**BOARD OF COMMISSIONERS OF THE PORT OF NEW ORLEANS**  
**NOTE TO PERSPECTIVE BIDDERS**  
**CONTRACT FOR**  
**HARMONY STREET WHARF**  
**ROOF REPLACEMENT**  
**DAMAGED BY HURRICANE KATRINA**

July 2, 2009

ADDENDUM NO. 1

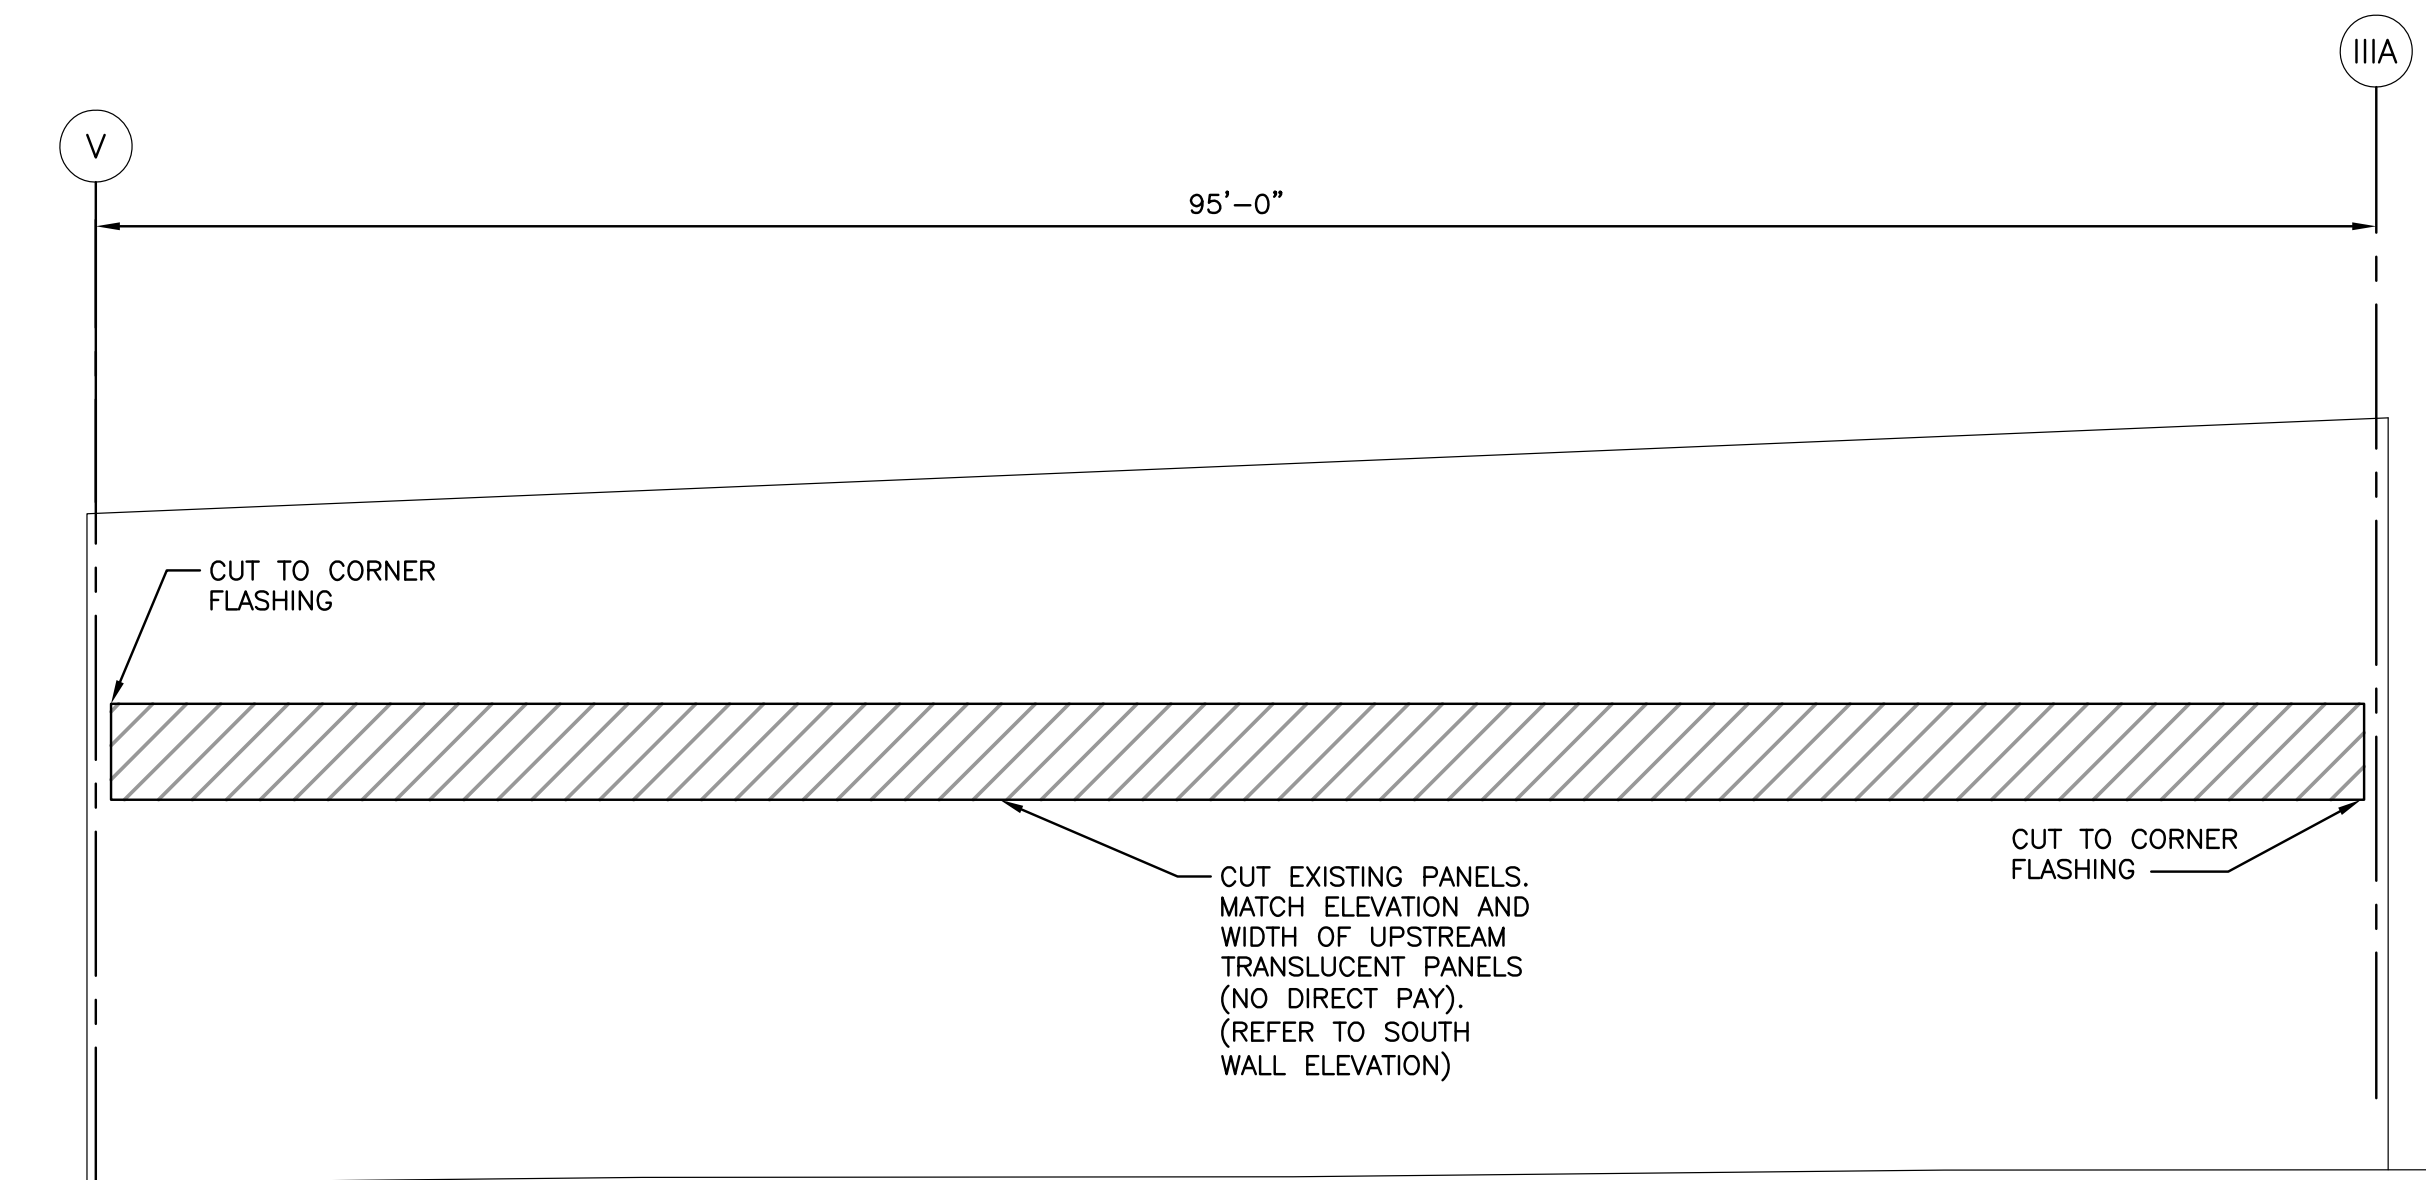
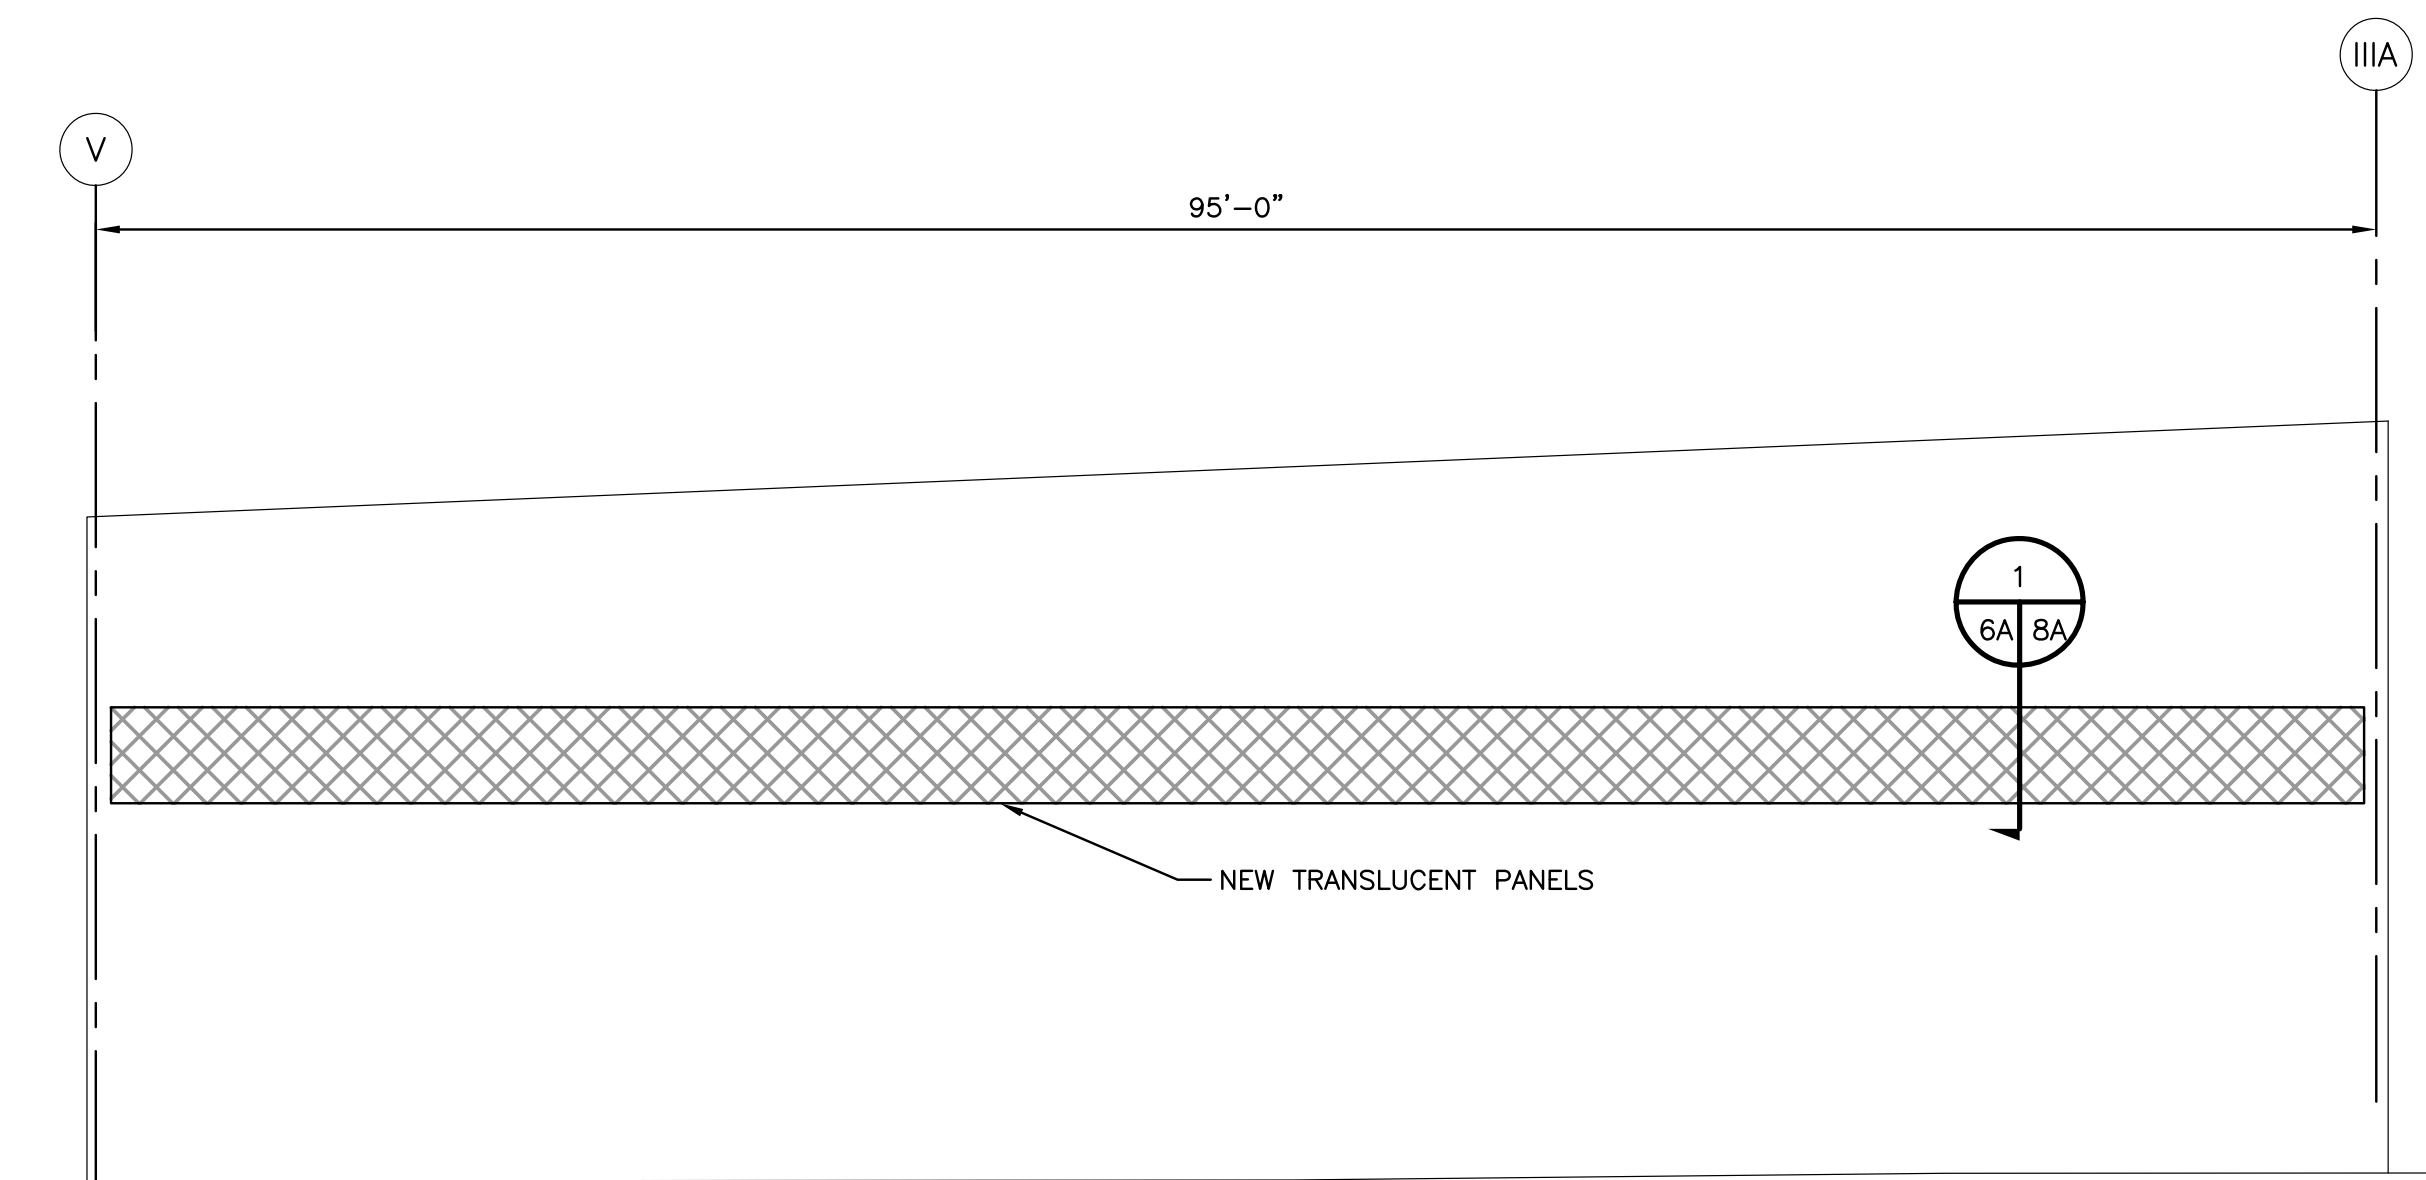
- Q: The plans only show 2 elevations (north, south, no west), the south elevation has existing translucent panels (partial south & partial west), the plans show installing new panels could you clarify?

- A: Drawing 6A addresses the west elevation and is included as part of this addendum.
- Q: Plans and specs have no dimensions for the cowls, please clarify.
